Prairie Island Nuclear Generating Plant Units 1 and 2  
Dockets 50-282 and 50-306  
Renewed License Nos. DPR-42 and DPR-60

Supplement to License Amendment Request (LAR) to Add Diesel Fuel Oil License Bases and Revise Technical Specifications (TS) 3.7.8, "Cooling Water (CL) System" and 3.8.3, "Diesel Fuel Oil" (TAC Nos. ME6849 AND ME6850)

Response to Requests for Additional Information (RAIs) for License Amendment Request (LAR) to Add Diesel Fuel Oil License Bases and Revise Technical Specifications (TS) 3.7.8, "Cooling Water (CL) System" and 3.8.3, "Diesel Fuel Oil" (TAC Nos. ME6849 AND ME6850)

NF-39232, "Flow Diagram Fuel & Diesel System Unit 1 & 2", Revision 80

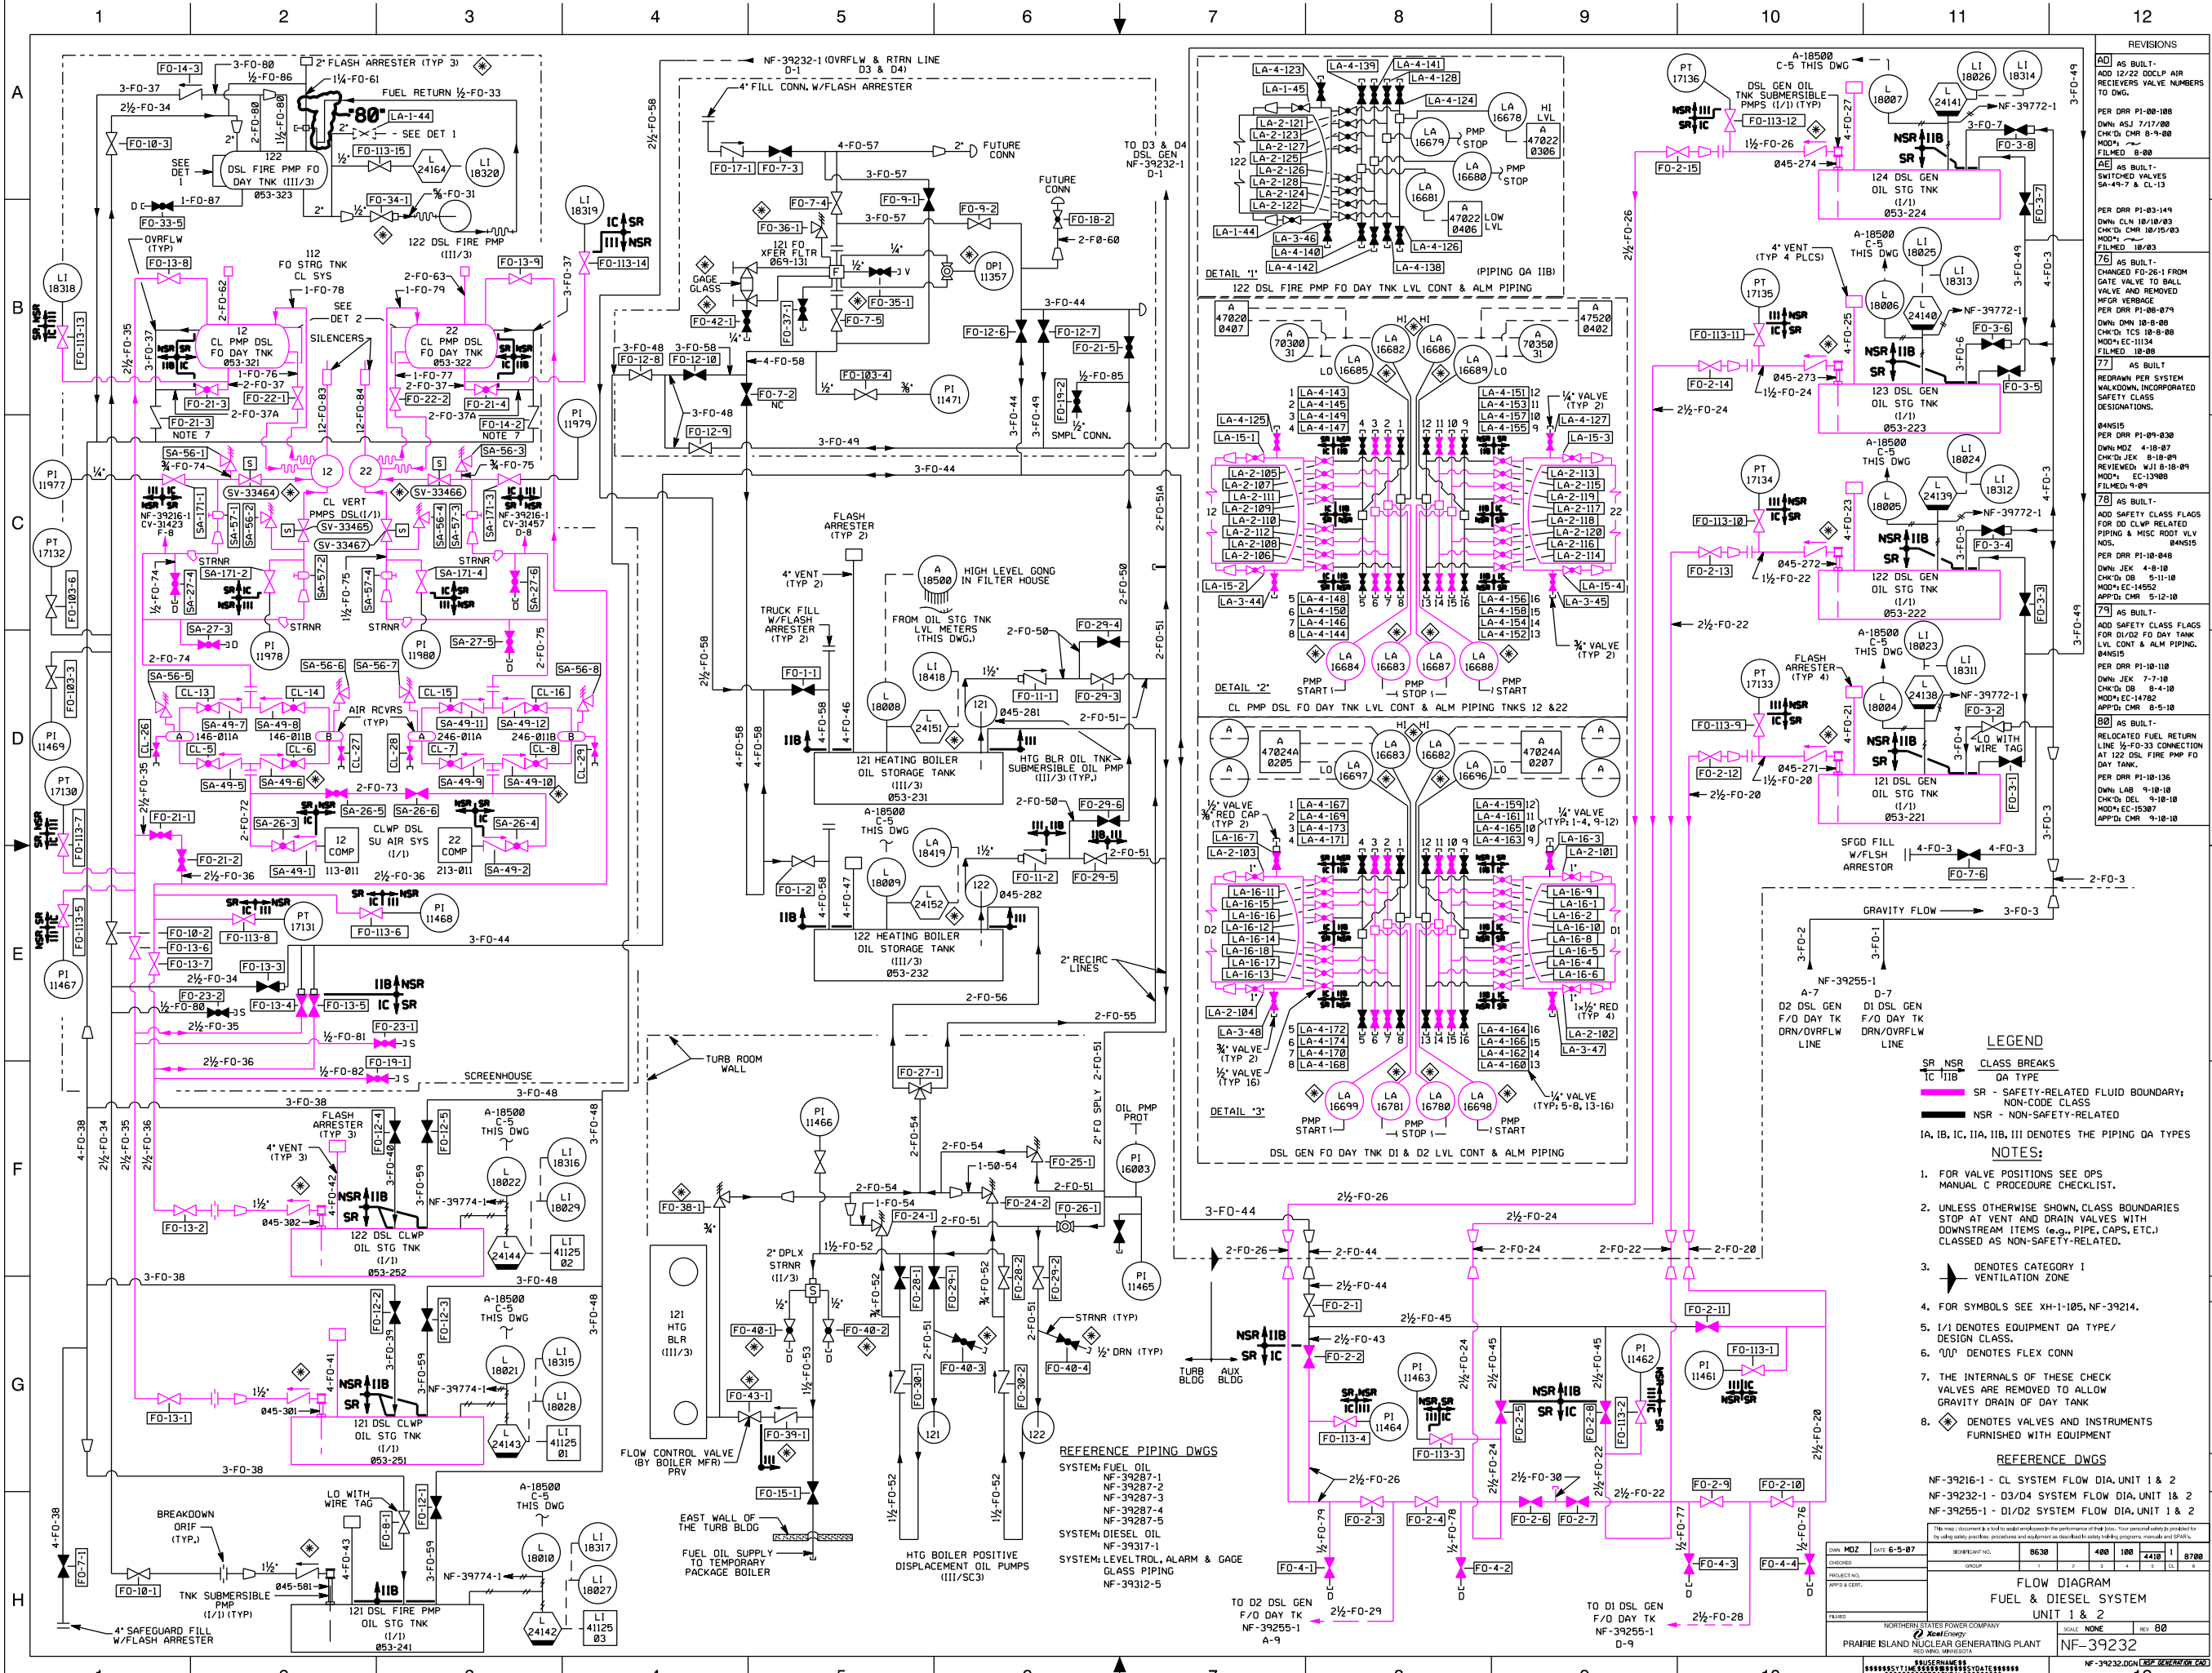
The LAR states that six Design Class I fuel oil storage tanks supply fuel oil to the two Unit 1 EDGs (D1/D2) and the two diesel driven cooling water pumps (DDCLPs). Each tank is equipped with a transfer pump to pump fuel from the tank to the nominal capacity 500 gallon day tank of either EDG or either DDCLP. The six tanks are interconnected such that any tank can be manually aligned to supply any diesel day tank and any combination of the six tanks can be used to meet the 14 day storage capacity requirement for a probable maximum flood. Please provide the following information:

- a) A flow diagram depicting the interties between the tanks and EDGs D1/D2 and the two DDCLPs, including valves that are required to operate for aligning the tanks. Identify the normal alignment required to satisfy TS requirements.
- b) Identify tanks and components that may be unavailable during routine and major maintenance activities and associated limiting conditions for operation (LCOs) that are applicable during the maintenance activities.
- c) Provide a detailed discussion on the power sources for each of the components required to align the fuel oil system for 14 day operation.
- d) Identify and provide a detailed discussion on the procedures that are used to validate each of the paths required to transfer fuel for 14 day operation of the EDGs and the DDCLPs.

See Attachment 1 to this Enclosure, flow diagram NF-39232, "Flow Diagram Fuel & Diesel System Unit 1 & 2", Revision 80. The normal flow path to satisfy TS requirements (provided as drawing equipment and pipe designations) follows:
